Detailed Site Plan
Alternative Compliance
Giac Son Buddhist Temple

DSP-20002
AC-22009

SUBJECT: Detailed Site Plan DSP-20002
 Type 2 Tree Conservation Plan TCP2-018-2023
 Alternative Compliance AC-22009
 Giac Son Buddhist Temple

Figure 1: Architecture Elevations

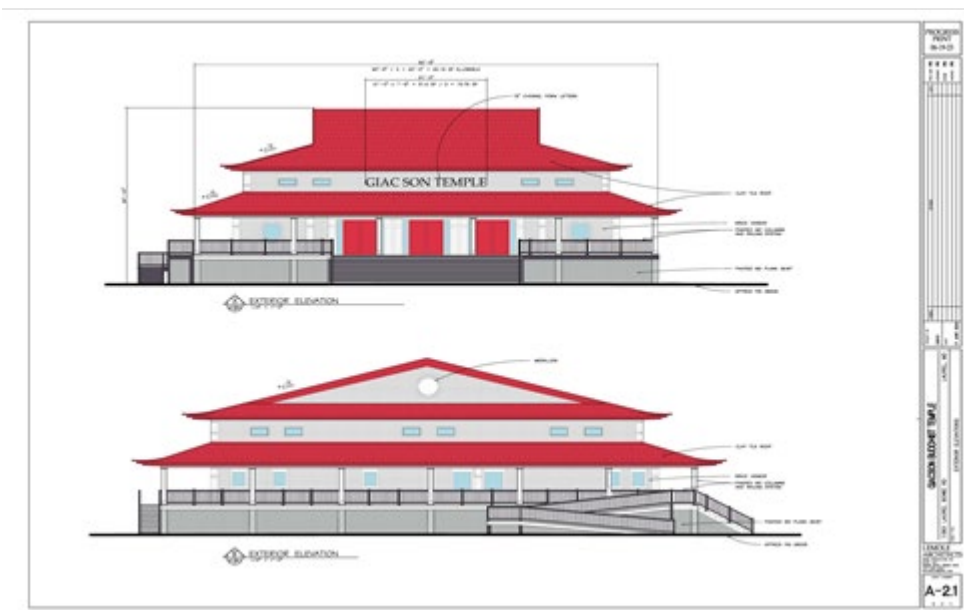
Staff find the proposed architecture to be sufficient, subject to conditions. These include revising the height of the proposed building labeled as Site Note 25 on the DSP coversheet to match the height provided on the architectural elevations; providing dimensions of the proposed building entrances; providing floor plans of the proposed place of worship; providing the material and colored elevations of the Buddha statue and courtyard; labeling the elevation facing Snowden Road as a side elevation on the architectural elevations and Site Note 26 on the DSP coversheet; and requiring the height of the Buddha statue to not exceed 15 feet, per Section 27-442(i) of the prior Zoning Ordinance.

- x. Revise the Buddha statue height to not exceed the requirements associated with Section 27-442(i) of the prior Prince George's County Ordinance, for properties in the Rural Residential Zone.

Figure 2: Institutional Building-Mounted Signage

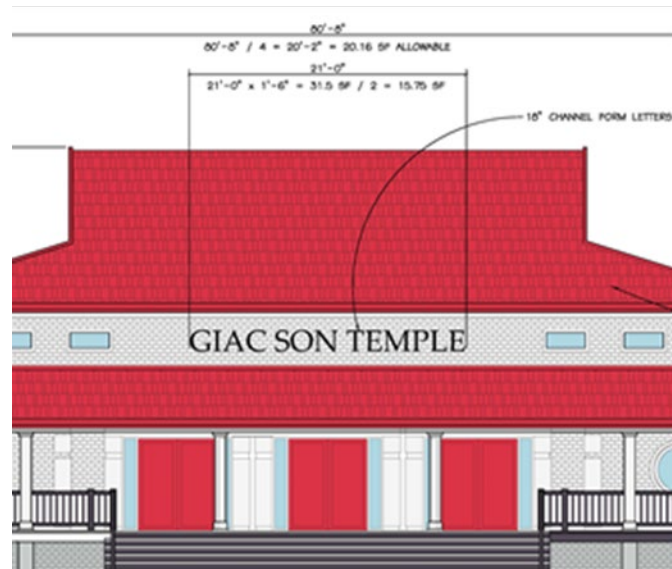
- j. Revise the architectural elevations on Sheet 7 to clearly label the material of the proposed attached signage.
- k. Provide a colored rendering of the freestanding signage proposed on Sheet 10.
